<b>Title - Sujet :</b> Churchill Water Line Replacement – Wapusk National Park	
<b>Solicitation No. - N° de l'invitation :</b> 5P420-20-0160/A	<b>Date :</b> August 28, 2020
<b>Amendment No. - N° de modification :</b> 001	
<b>Client Reference No. - N° de référence du client :</b>	
<b>GETS Reference No.   N° de référence de SEAG :</b> PW-20-00923162

## Amendment 001

This amendment is being raised to distribute questions and answers.

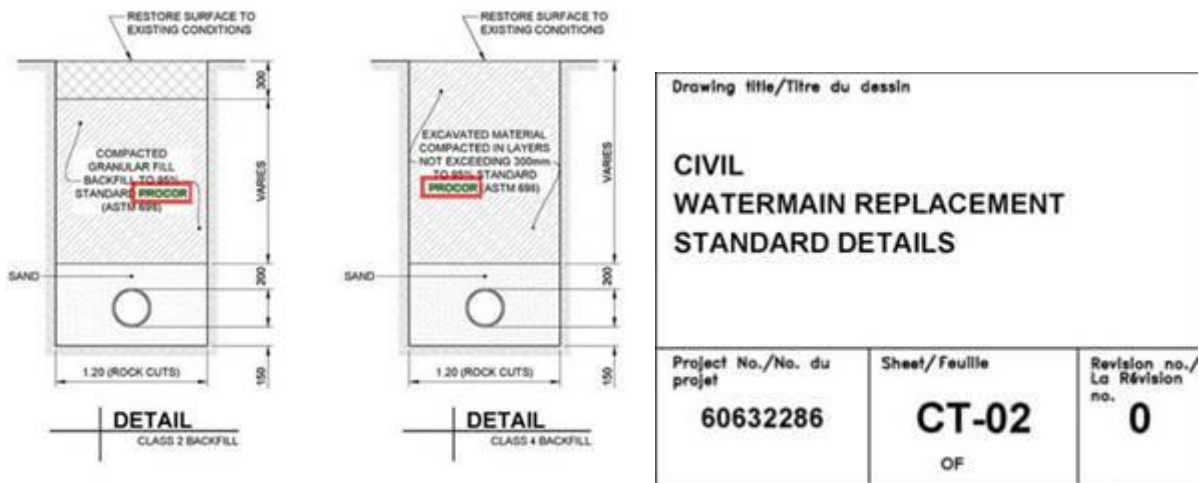
**Q2** Our pipe supplier is concerned about sealing the 32mm pipe inside the 75mm casing so that sewage can't travel back up the casing. Do you have any thoughts on this?

**A2** Where the 32mm sewer connects to the manhole, the casing is to stop outside the manhole at the outer face of the manhole wall, therefore the annulus of the casing is not subject to sewage backup.
